TI_2124: Reworking Combi-Duo electric left hinged 2/1

iCombi Pro / Classic

12/10/2021

Combi-Duo electric left hinged (manufactured before 30/09/2021):

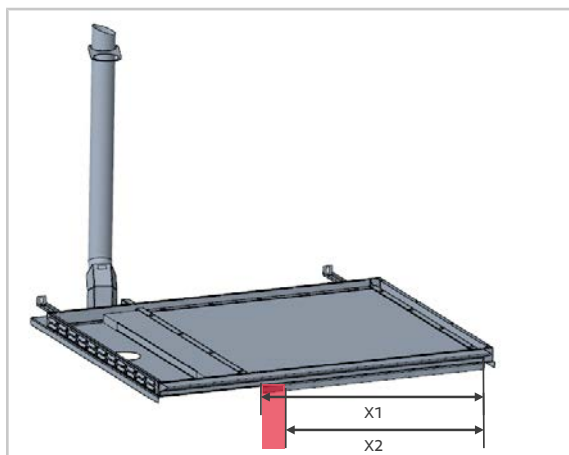
The bend on the Combi-Duo kit for left hinged units is too long by 17 mm [2/3 inch].

Rework is necessary for units manufactured before 30/09/2021.

If the Combi-Duo is used in conjunction with left hinged units, the bend must be shortened by 17mm.

Dimensions	mm [inches]
X1 (Actual)	711 mm [28 inch]
X2 (target)	694 mm [27 1/3 inch]
